Al-Muslim Apparels Ltd.

12 Nishchintapur, Ashulia, Savar, Dhaka
(23.92470, 90.30938)
10th November 2020

Building Information

Electrical Cables have been cut into and pass through main structural beams

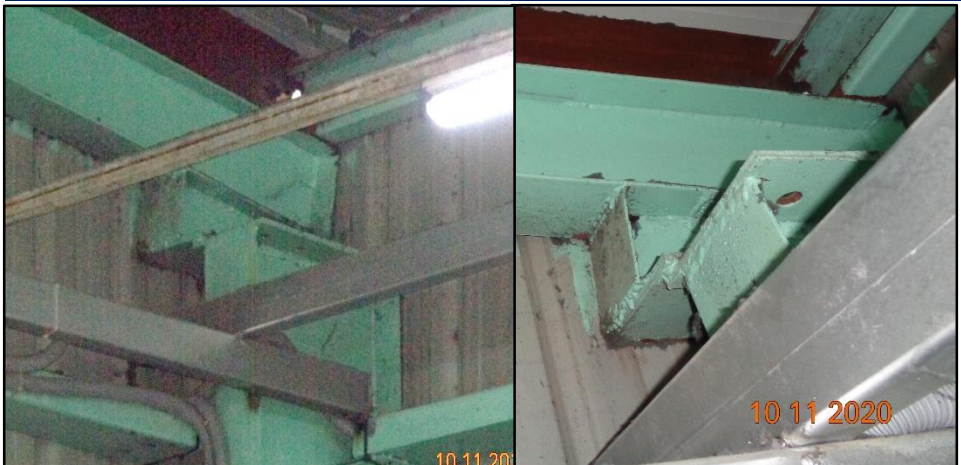
Electrical cables have been cut into and pass through main structural beams. Structural Engineer to Investigate and report on this matter to verify the Structural Integrity of the beams are not compromised

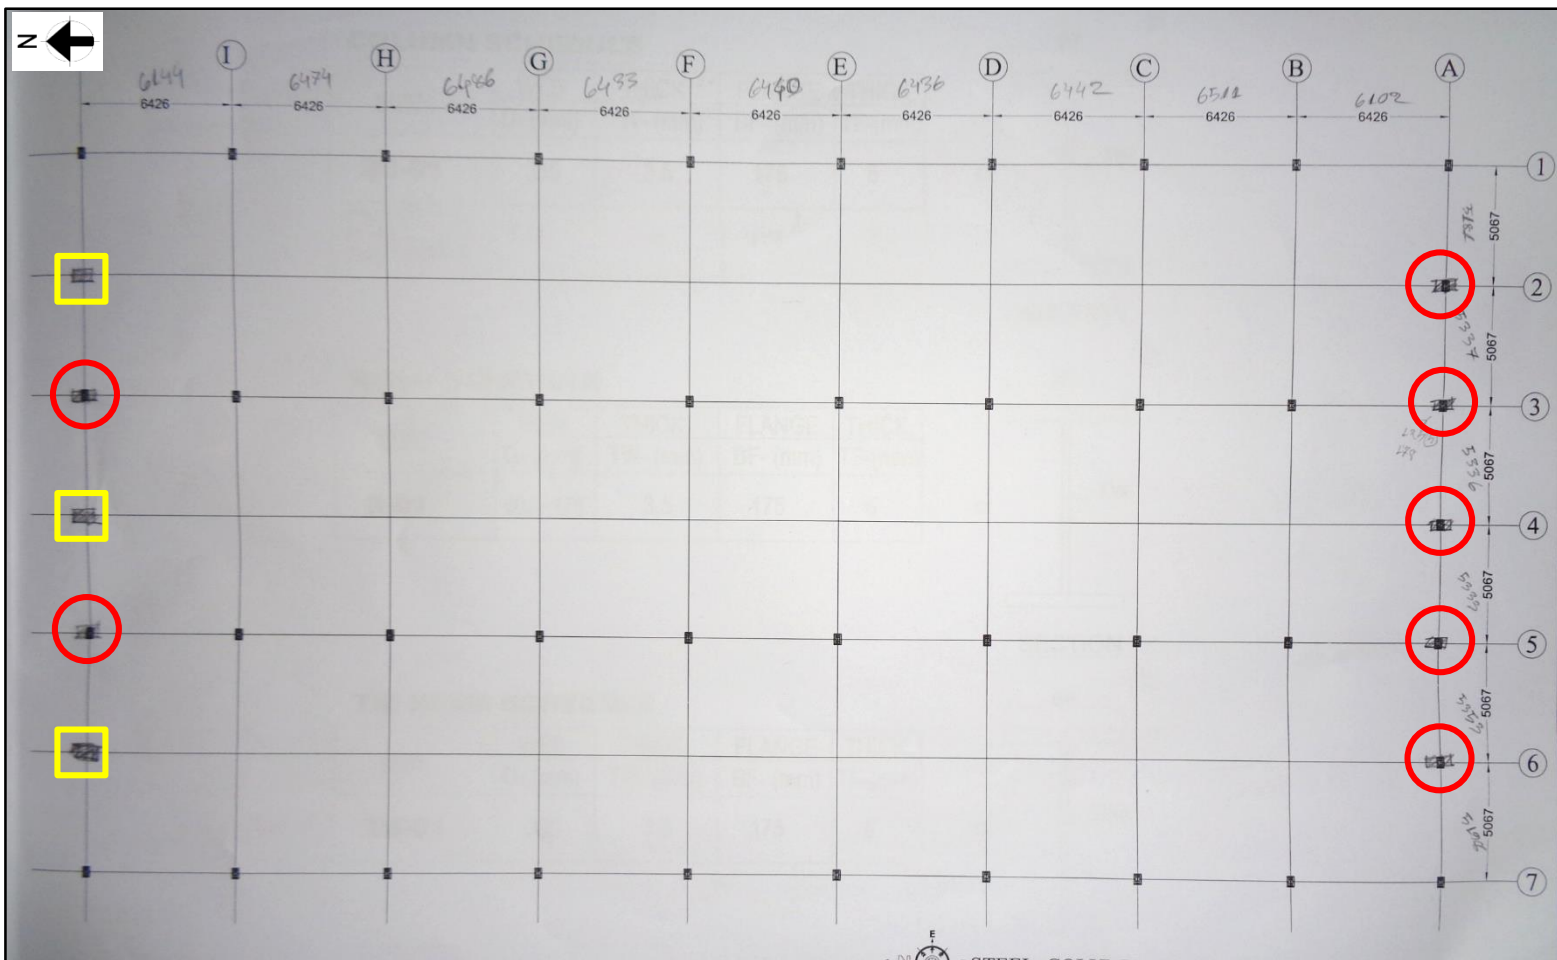
Compression strut in long direction was not observed. Also Roof & wall bracing was found missing

Roof and wall bracing were not found to resist lateral loading along the long direction. Also, few non-engineered connection was found in between rafter & Column.

Factory engineer is required to check the stability of the structure for lateral loading and to check the connection adequacy accordingly.

Column Layout Plan

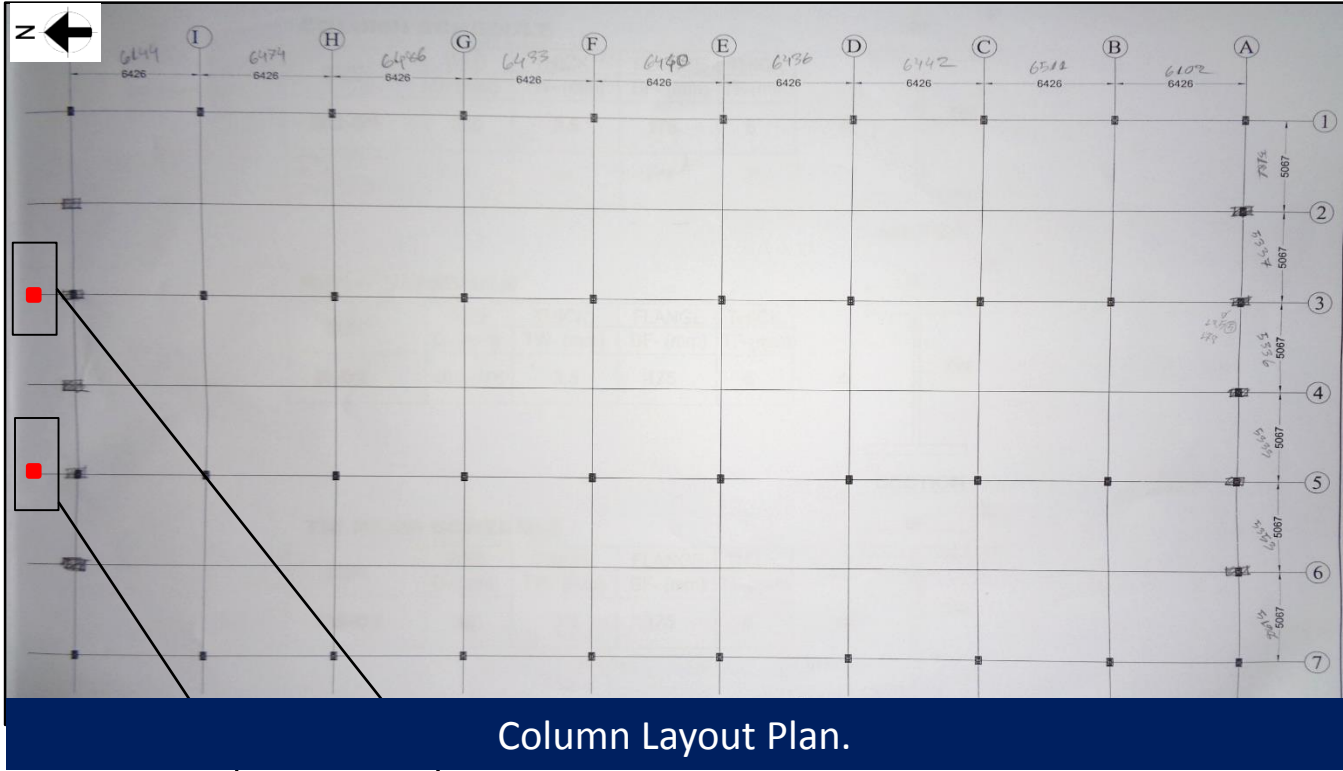
Orientation of the steel column found different between as built drawing and actual site condition at circle marked location.

Three numbers of extra columns were found at actual site condition which are not mentioned in as-built drawing. Mismatches are shown in rectangle marked at column layout.

Factory engineer is required to survey the structures and prepare as-built drawings that are compliance with section 1.9.1.2 as per BNBC.

Connection of Canopy

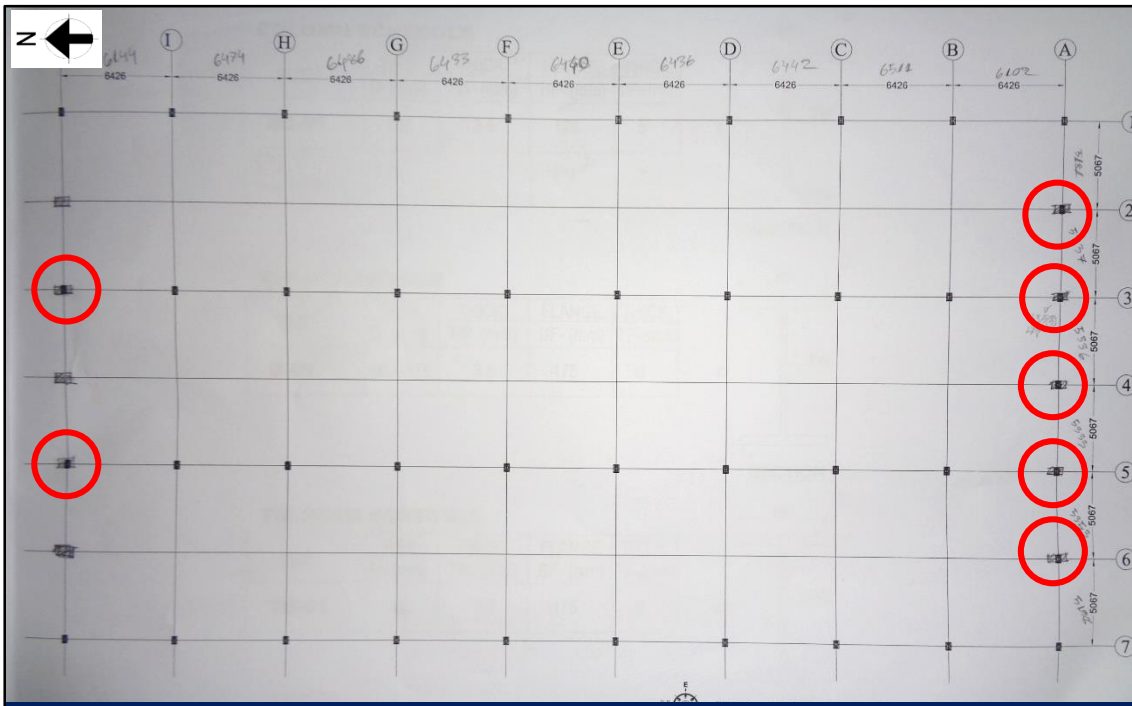
Canopy was found at north side of the structure. The column of the canopy has not been shown in as-built column layout plan. The marked locations denotes the canopy column location.

Measurement of the Steel column

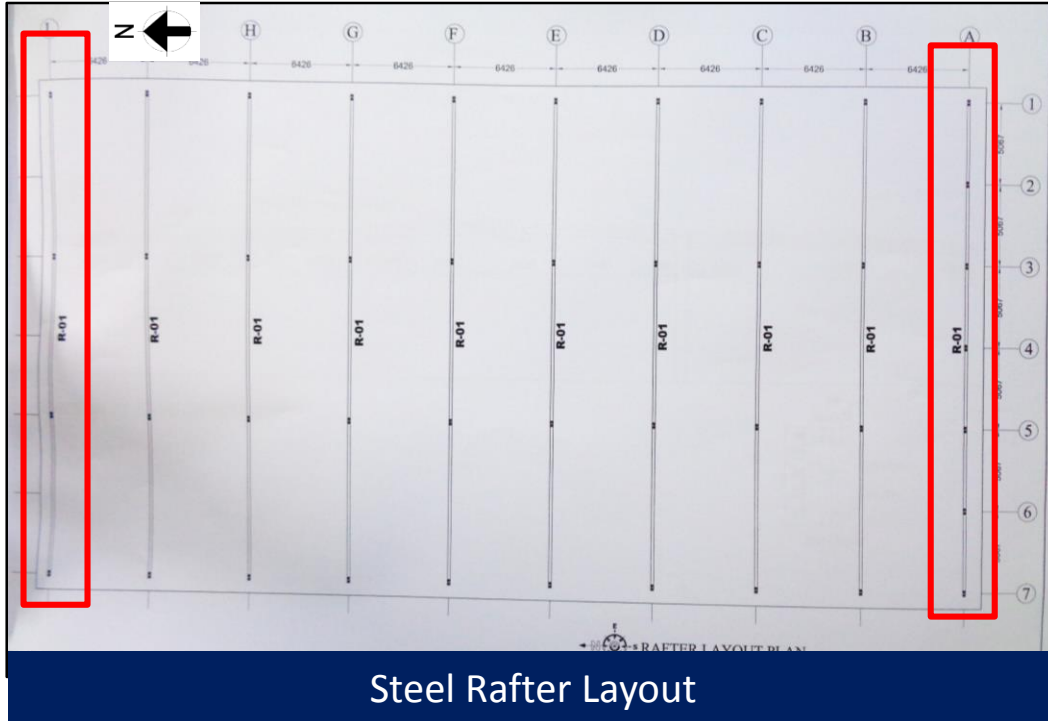
Column size at marked location was found mismatched with as-built drawing. During inspection, column size was found Web: 175 & Flange: 125X5. In as-built drawing the column size has been shown Web: 350X3.5 & Flange: 175X5.

Rafter size at marked location was found mismatched with as-built drawing. During inspection, Rafter size was found Web: 175 & Flange: 125X5. In as-built drawing the Rafter size has been shown Web: 400~175X3.5 & Flange: 175X5.

Corrosion in steel member

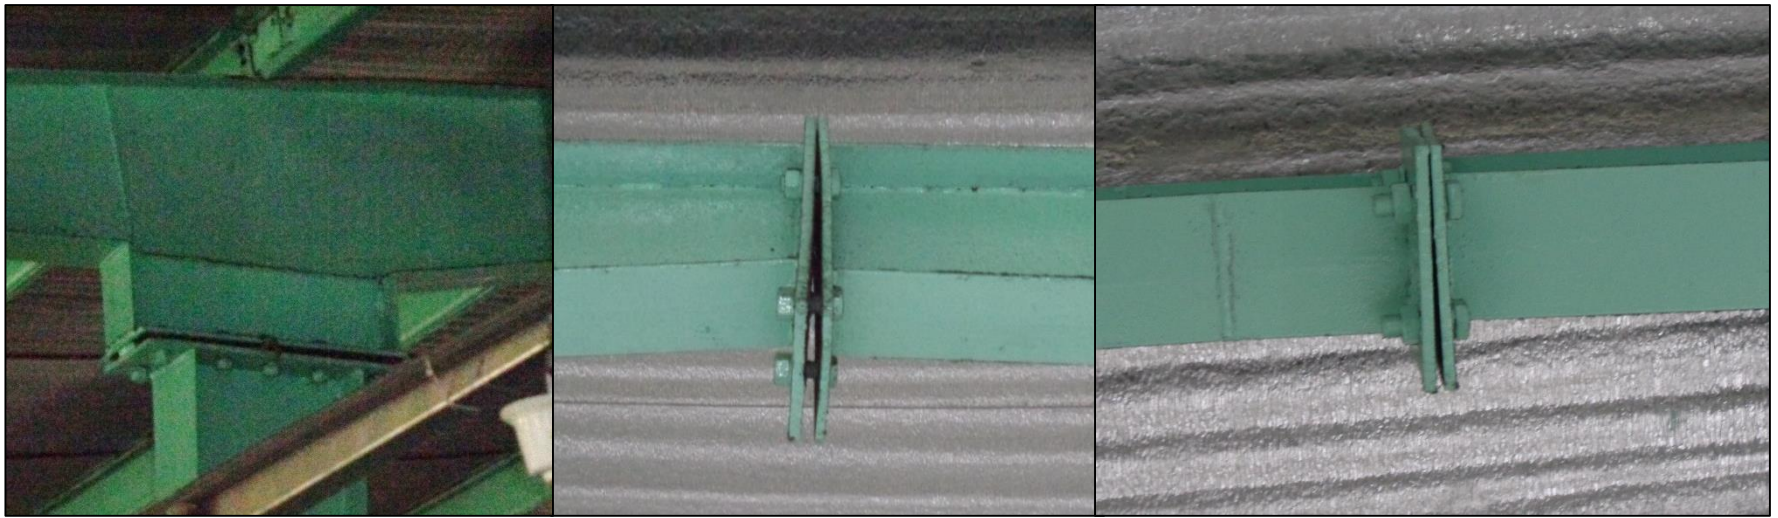
Corrosion in steel member was found in various locations. Factory is required to identify the corroded locations and investigate the reason of corrosion and suggest proper remedial measure accordingly.
